Re: Gold Fields Limited
Form 20-F for the year ended June 30, 2006
Filed on November 24, 2006
File No. 001-31318

Engineering Comment

Reasons underlying the downward revisions of the estimates of the below infrastructure Reserves at Kloof Mine, including a comparison of the below infrastructure Reserves at Kloof and at Driefontein.

F2005 VCR Facies Model (New)

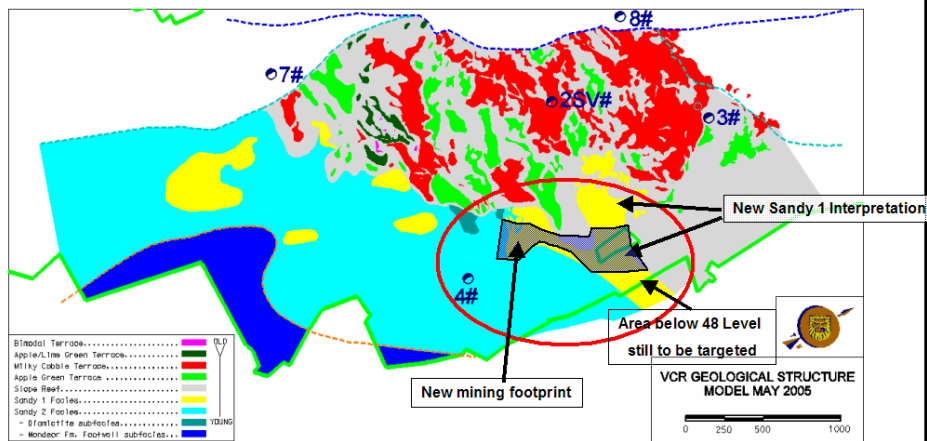
New VCR facies model (see attached slide)

- With the desire for continuous improvement and resolution, the new VCR model for the F2005 declaration evolved to incorporate all the latest 3D seismic modelling and all the surface and underground drilling data, together with local and regional sedimentological studies involving an independent consultant for peer review. The result is that there is a clear view of the strategically important and prospective ground below infrastructure at Kloof. EBA accounts for 42% of the group's annual resource reduction (31 to 21 Moz).

F2004 VCR Facies Model (Old)

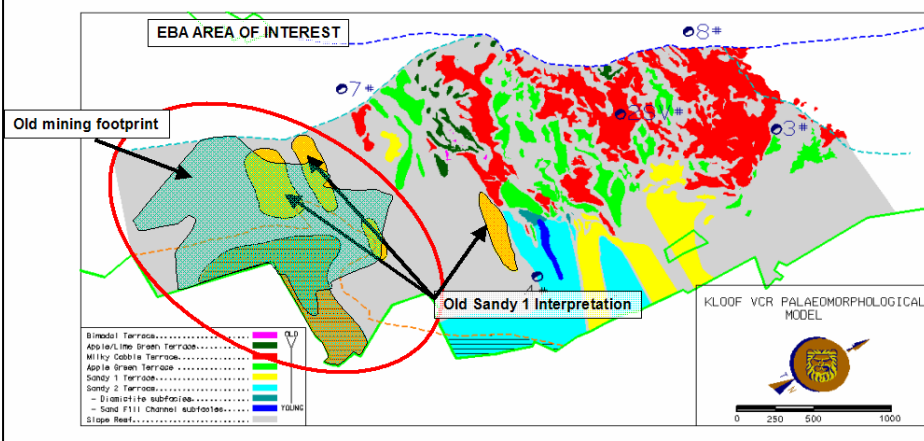
Old VCR facies model (see attached slide)

- This plan covers an area approximately 2 Km on-dip and 5 Km on-strike. It shows the VCR palaeogeomorphological model at Kloof and depicts the fluvially derived slope and terrace topography that was frozen in place by the overlying lavas. Proximally we have a very good understanding of the detailed nature of the VCR in the areas contiguous to current and historical mining. More distally and at greater depth the orebody behaves differently.
